City of Pawtucket, RI

***** **Addendum #2** *****

RFP # 26-023

Oak Hill Park Tennis Courts & Playground Renovations

CONSTRUCTION SITE PLAN

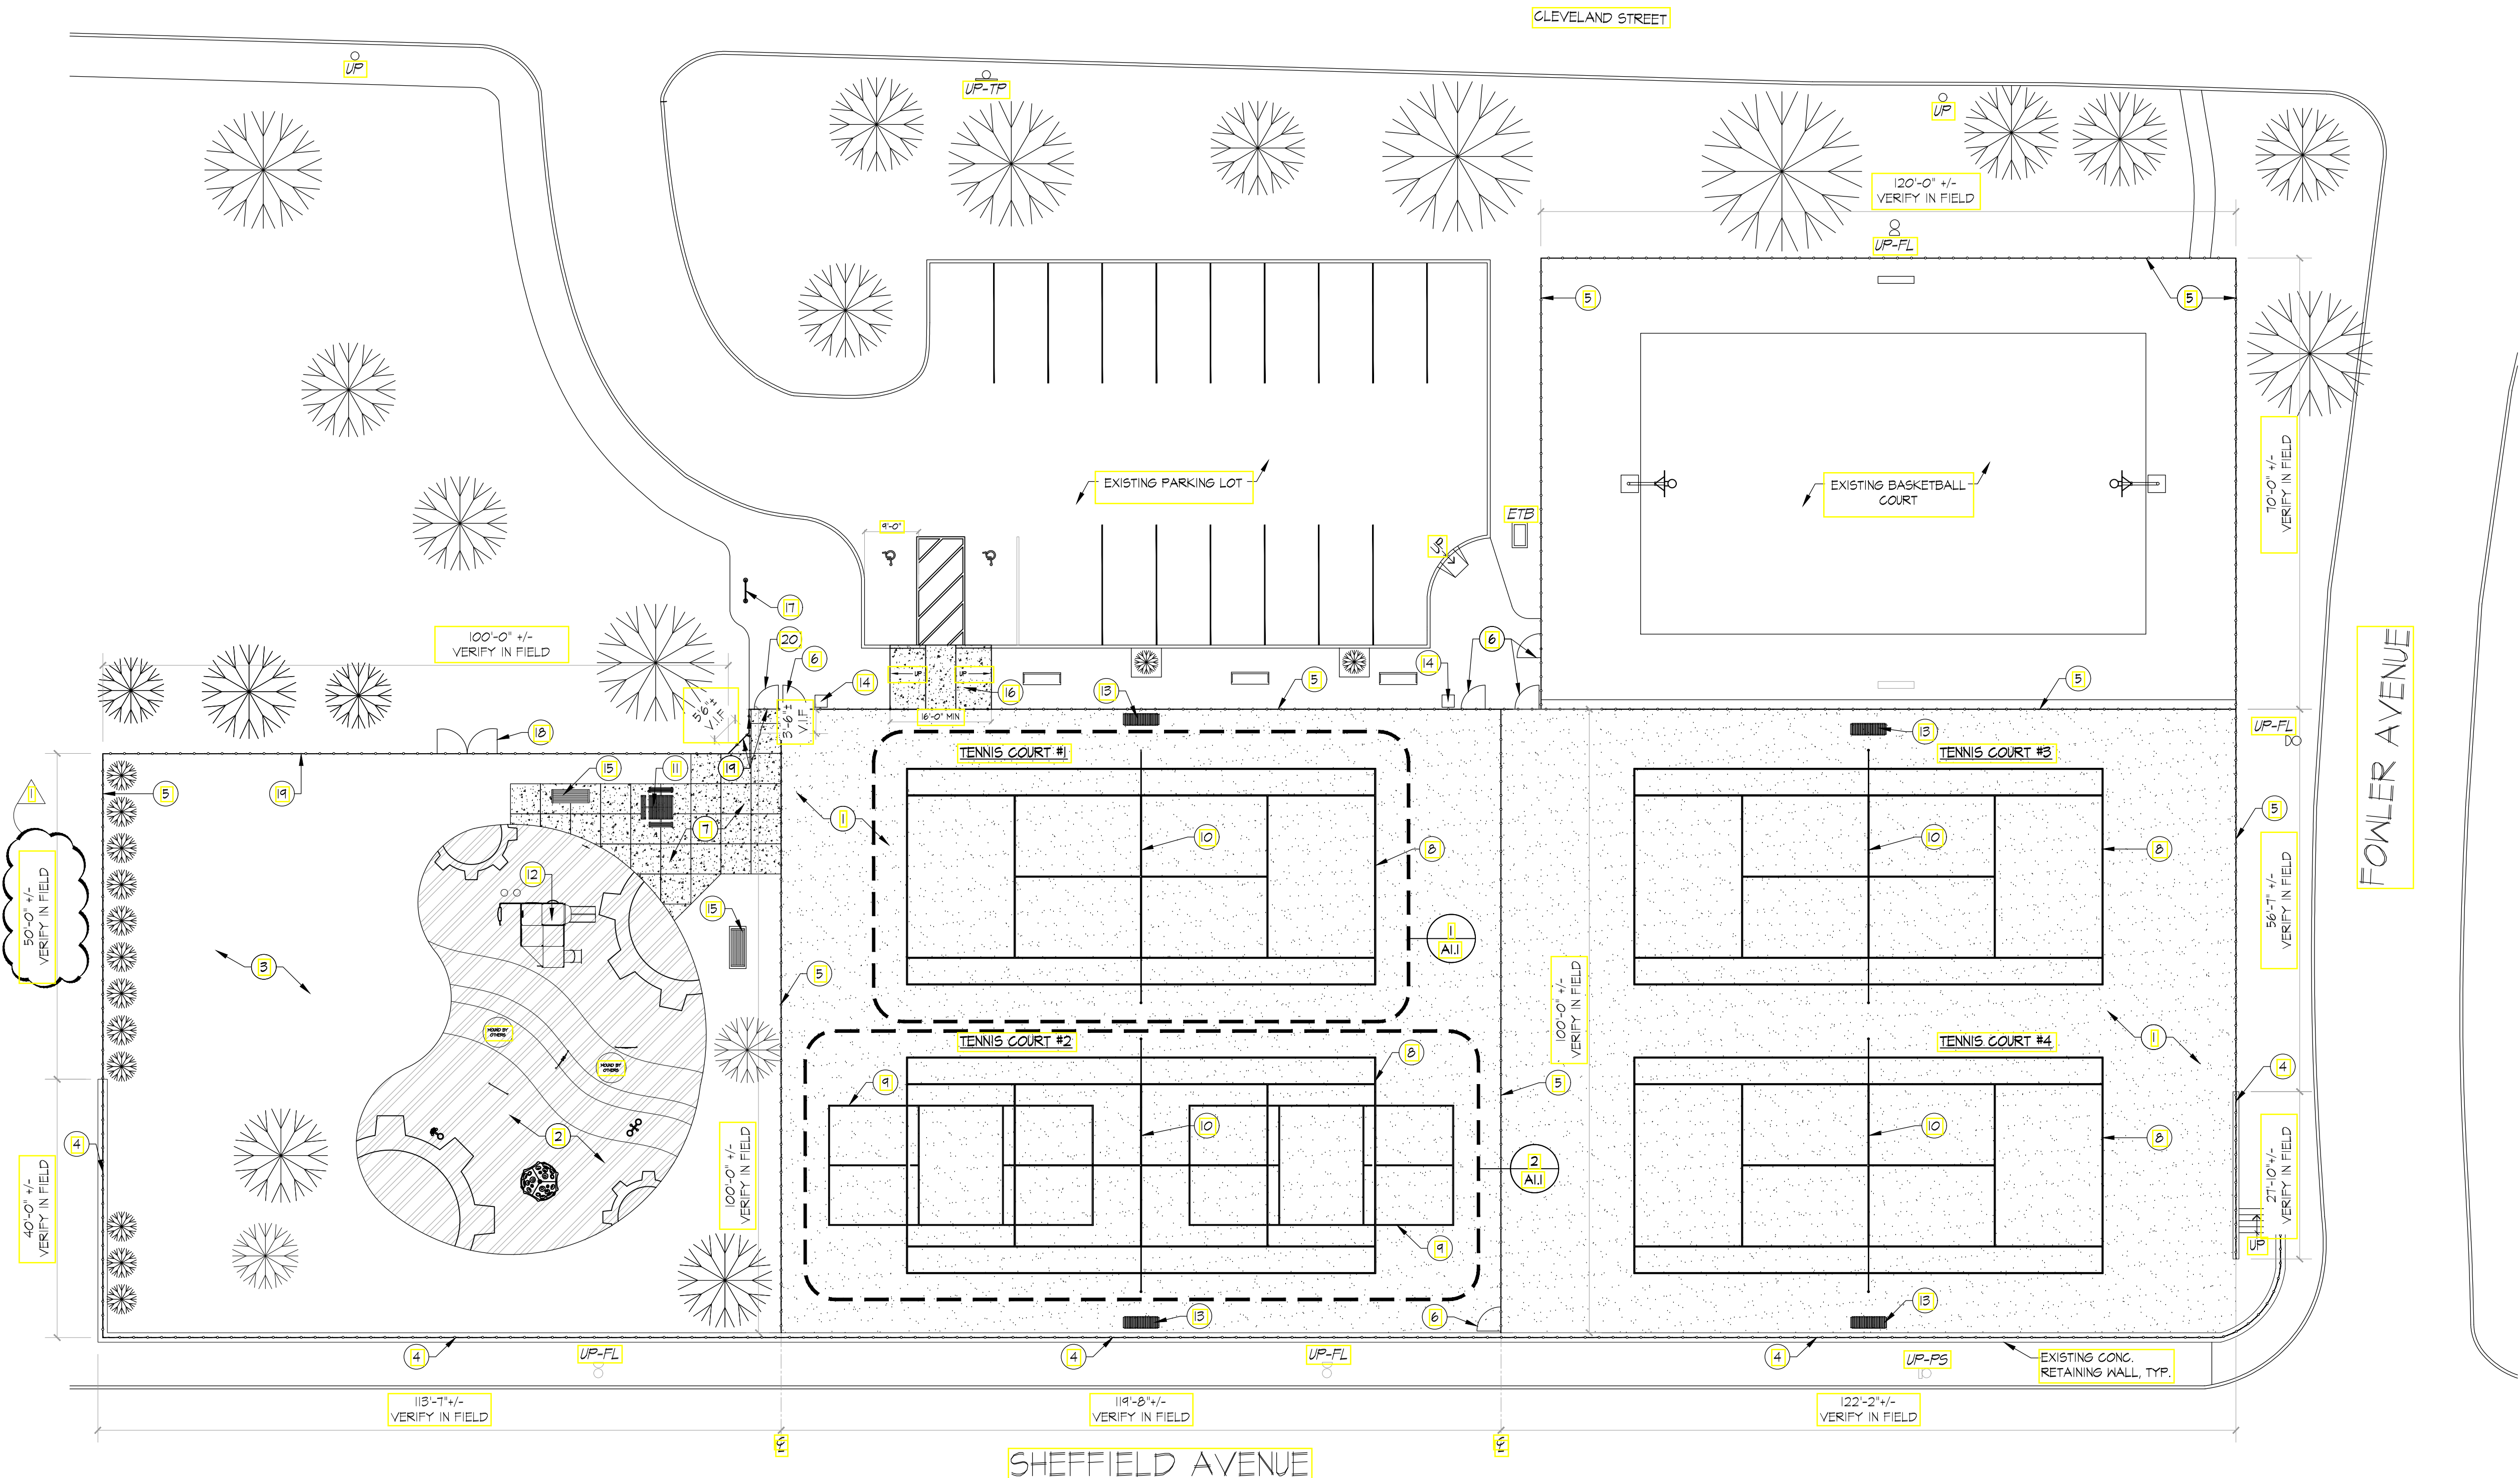
1. There are some scale issues on the A plans. The A plans show written dimensions that do not scale properly and claim to “verify in field”. Once verified in field, the

measurements on the left side of the A plans do differ from what is existing. That should not be. Which plans override?

Please see revised dimension on the attached plan.

REVISED DIMENSION 8/25/26
